# Methanol Plant and Product Export, Burrup Peninsula

**Australian Methanol Company Pty Ltd**

Report and recommendations of the Environmental Protection Authority

Environmental Protection Authority Perth, Western Australia Bulletin 1075 November 2002

Figure 4: Vegetation communities and plant layout (Source: URS, 2002, amended Figure 11. Referenced from Trudgen, 2002)

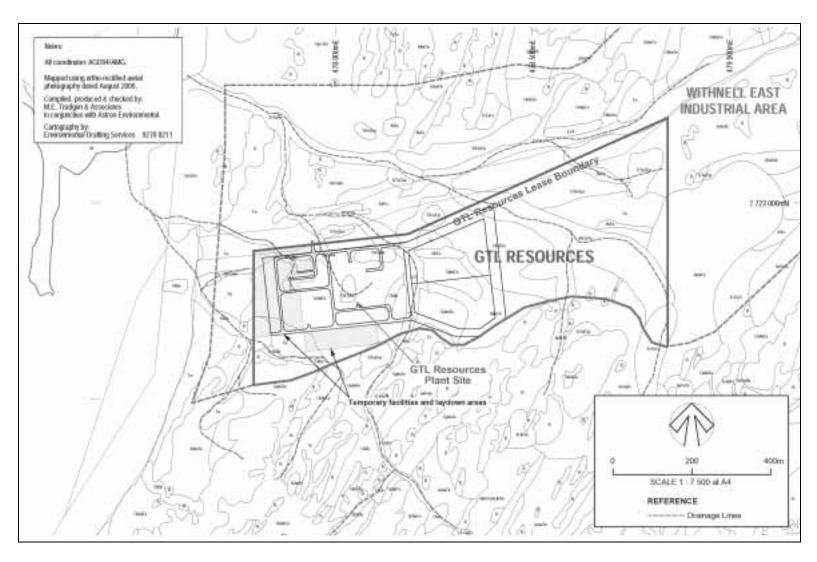
The EPA notes that on the definition of vegetation communities, based on the Trudgen (Trudgen 2002) mapping of vegetation associations, applied to the site survey, some communities found on the site will be impacted in a regional context. This arises, not because a large proportion of the community is being destroyed by the plant site, but because of the naturally restricted area typical of vegetation communities found on the Burrup and because of the amount of the community found within areas set aside for industrial development. No vegetation community will be reduced below 30% of its total extent by this proposal. There is the potential for the community TrTe(Ta) to be reduced below 30% of its original extent by continued development in the industrial area and future developers should be aware of this.

The EPA endorses the proponent's commitments to establishing and implementing Flora and Vegetation Management Plans to address site clearance procedures, procedures for rehabilitating areas of temporary disturbance, seed collection of any prominent flora species present, including Priority Flora species, to ensure the availability of species for rehabilitation, germination trials prior to and following construction, with a particular focus on the Priority 1 species *Terminalia supranitifolia* and restoration of Priority Flora species disturbed by the project.

Figure 5: Maximum predicted ground level  $NO_2$  concentrations ( $\mu g/m^3$ , 1 hour average) from existing sources plus this proposal (Source: URS, 2002, Figure 7-2, Appendix G)

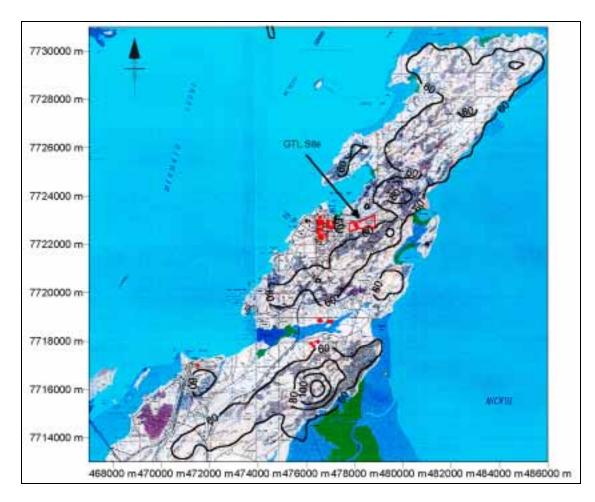
Modelling of  $NO_X$  emissions under normal operating conditions and at start up has been carried out. The modelling of current sources (Hamersley Power Station, Woodside Trains 1-3, Syntroleum, Burrup Fertilisers and Dampier Nitrogen Ammonia-Urea plant) combined with this proposal predicts a maximum one hour average ground level concentration of nitrogen dioxide ( $NO_2$ ) 143 micrograms per cubic metre ( $\mu g/m^3$ ) (Figure 5). This proposal without other sources of emission would result in a maximum one hour average  $NO_2$  concentration of 59  $\mu g/m^3$ . The National Environmental Protection Measure (NEPM) standard for  $NO_2$  of 246  $\mu g/m^3$  will not be exceeded in residential areas.

As detailed engineering designs have yet to be done and it is possible that some aspects of the plant equipment and layout may change in the final design, with some effect on the emission of  $NO_x$ , the EPA feels that it is appropriate for the proponent to confirm engineering design details for emissions, demonstrate that these are best practicable  $NO_x$  control, estimate non-normal operating condition emissions and remodel to confirm previous predictions prior to submitting a works approval application. The EPA has recommended condition 9-1 accordingly. Remodelling at this later date will also allow the incorporation of up to date emission figures from other currently proposed industries in the region and modelling to more accurately take into account the meteorological and terrain conditions of the Burrup Peninsula. The Department of Environmental Protection should be consulted regarding appropriate modelling methodology. The EPA encourages industry, together with the Department of Environmental Protection and the Department of Mineral and Petroleum Resources, to develop a more appropriate air quality model for the Burrup.

Figure 6: Water systems flow diagram (Source: URS, 2002, Figure 7)

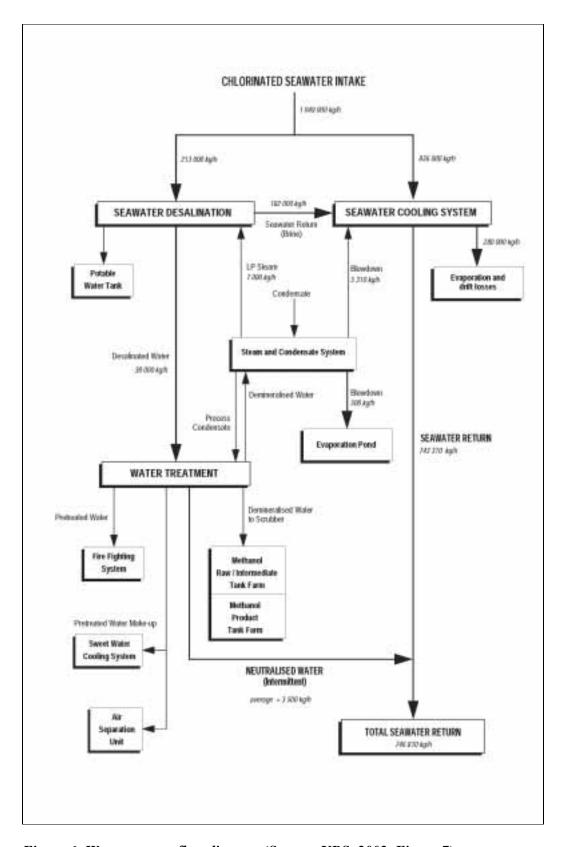
Ammonia is both a toxicant and a nutrient. The original proposal in the PER (URS, 2002) was to discharge all ammonia from the process to the outfall. This would have resulted in an ammonia concentration exceeding the ANZECC 99% species protection trigger level at the edge of the outfall mixing zone and a contribution of 50t/a of nitrogen to the marine environment. The proposal has now been amended to include steam stripping of process condensate, which will remove most of the ammonia from the process condensate and return the ammonia as steam to the steam reformer. It is estimated for the amended proposal that at the point of discharge the concentration of the remaining ammonia after dilution with return seawater will be 0.23 mg/L as nitrogen which is below the ANZECC 99% species protection trigger level of 500  $\mu\text{g/L}$ . After dilution at the edge of the mixing zone the concentration will be approximately  $20\mu\text{g/L}$ . The ammonia discharge will add approximately 2t/a of nitrogen to the marine environment.

The EPA commends the proponent for amending the proposal to significantly reduce the amount of ammonia proposed for discharge to the marine environment and for committing to demonstrating best practicable technology. The discharge of nitrogen compares to the current Methanex proposal which will also discharge approximately 2t/a of nitrogen for a five times greater production. If further reductions are found to be practicable during the design stage of the plant, the EPA would encourage the proponent to implement these.
